Product Change Notification

Date Issued :	July 17, 2026	PCN Number :	518475
Reason for Change :	Packaging Method/Quantity Change		
PCN Subcategory:	PCQC - Label Change		
Description of Change :	This notification is to inform you about part(s) listed in this notice will undergo changes to the label. No changes will be made to the product as a result of this change.		
Planned Implementation Date :	January 17, 2027		
Last date to request Samples by Customer : July 31, 2026			
Please note if Samples are not requested as per Customer Samples Request date, it may take additional 4-6 weeks to arrange Samples.

General Market ID + Marking Updates

Molex GM Historical ID + Marking

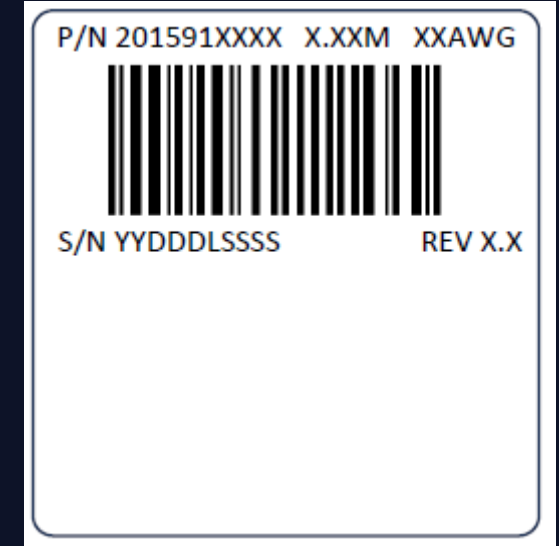
- Serial Number Format
 - YDDLSSSS or YYDDLSSSS
 - YY = 2 digit year
 - DDD = 3 digit day of year
 - L = 1 digit location code
 - SSSS = 4-digit base10 serialization 0000-9999
- Serial Number Uniqueness
 - Serial number is unique to the part number
- Barcode Format
 - Serial number only e.g. YYDDLSSSS

- Serial Number Format + Serial Uniqueness
 - Daily limit of 10,000 serial numbers
 - SSSS = 4-digit base10 serialization 0000-9999 limits the total number of pieces per day to 10,000
 - Daily limit forced us to configure serialization to be unique to the part number
- Barcode Format
 - Barcode content only contained the serial number; this caused confusion with customers buying multiple Molex part numbers
 - Some customer systems cannot recognize per-part number uniqueness; their systems require the part number in the barcode to verify no duplicates within a part number
 - Some customer systems require the part number in the barcode as part of their inventory control system

Molex GM 2026 ID + Marking

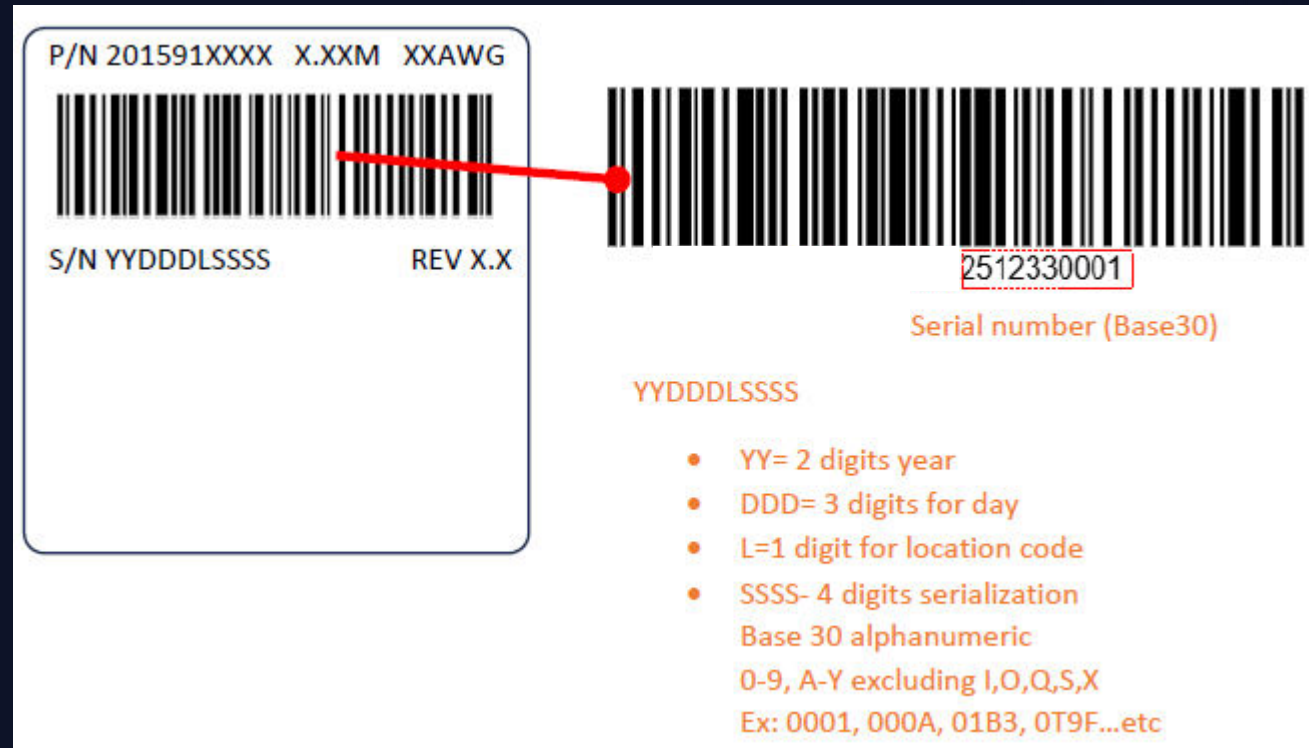
- Update from Base10 -> Base30 Serialization
 - Base30 serialization allows us to support up to 810,000 unique serial numbers per day; this will allow us to group ALL part numbers together to ensure no duplicates across part numbers
